## Access Compliance Report Public Rights-of-Way (Curb Ramps)

Intersection ID: 10020377 Main Street: BALLANTYNE\_CORPORATE\_PCross Street: N/A Location: NW

ADA ID: 8D396212162D Ramp Type: Perp Initial Pass/Fail: Fail Overall Compliance: No Severity Score: 13.75

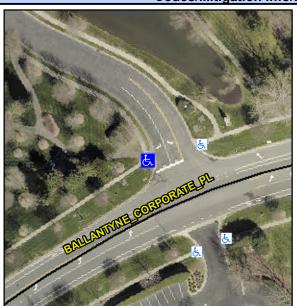
Not Found, R304.2.2, R304.5.3

Field Measurements/Component Compilance					
Compliance Description		Data	Compliance Description		Data
N/A	Ramp Length (in)	140.0	No	Ramp Slope (%)	9.0
Yes	Ramp Width (in)	48.0	No	Ramp XSlope (%)	4.3
N/A	Flare Type LT	N/A	N/A	Flare Type RT	N/A
N/A	Flare Slope LT (%)	N/A	N/A	Flare Slope RT (%)	N/A
N/A	Flare Traversable LT?	N/A	N/A	Flare Traversable RT?	N/A
N/A	Landing Length (in)	N/A	N/A	DWS Provided?	N/A
N/A	Landing Width (in)	N/A	N/A	DWS Contrast?	N/A
N/A	Landing Slope (%)	N/A	N/A	DWS Length (in)	N/A
N/A	Landing X Slope (%)	N/A	N/A	DWS Full Width?	N/A
N/A	Landing Curb? (Y/N)	N/A	N/A	DWS Offset (in)	N/A
N/A	Shared Landing?	N/A			
N/A	Gutter Ponding?	N/A	N/A	Gutter Slope (%)	N/A
N/A	Gutter Lip Ht (in)	N/A	N/A	Gutter X Slope (%)	N/A
N/A	Painted X Walk1?	No	N/A	Painted X Walk2?	N/A
	X Walk 1 Direction	То Е		X Walk 2 Direction	N/A
N/A	X Walk 1 Width (in)	N/A	N/A	X Walk 2 Width (in)	N/A
	X Walk 1 Slope (%)	2.8		X Walk 2 Slope (%)	N/A

Remove & Replace Entire Ramp.
